MINUTES OF MEETING: Thursday 29 - Friday 30 November 2018
Auckland Transport offices, 20 Viaduct Harbour
Room 1.03 (Thursday) and Room 1.01 (Friday)

Target shoulder seal width for state Highway Cycling Network

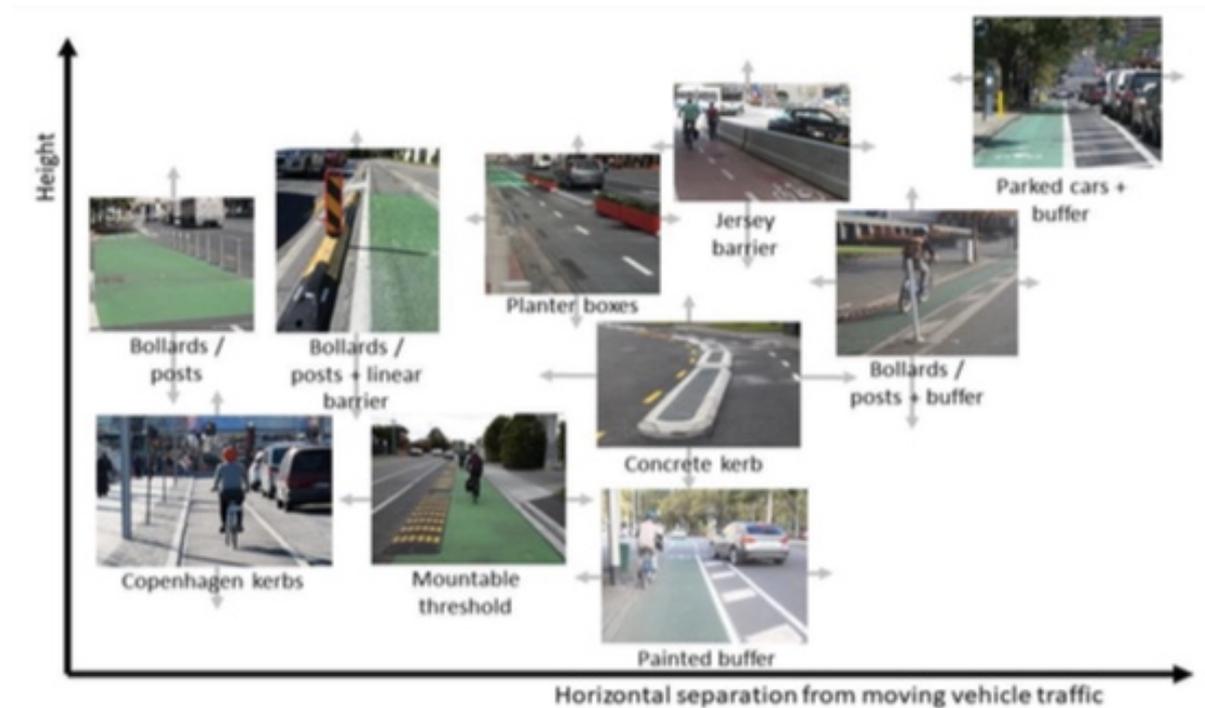
S. Kennett presented a revised table of shoulder widths, already incorporated into the new Specifications, based on the national gradings of the network done to produce the New Zealand Cycle Trails routes. The result is a more nuanced set of target shoulder widths for the state highway cycling network.

6. **S. Kennett** to amend Table 1 of the Specification for Design, Construction and Maintenance of Cycling and Shared Path Facilities from “target shoulder seal width” to “Minimum shoulder seal width for state highway cycling network”.
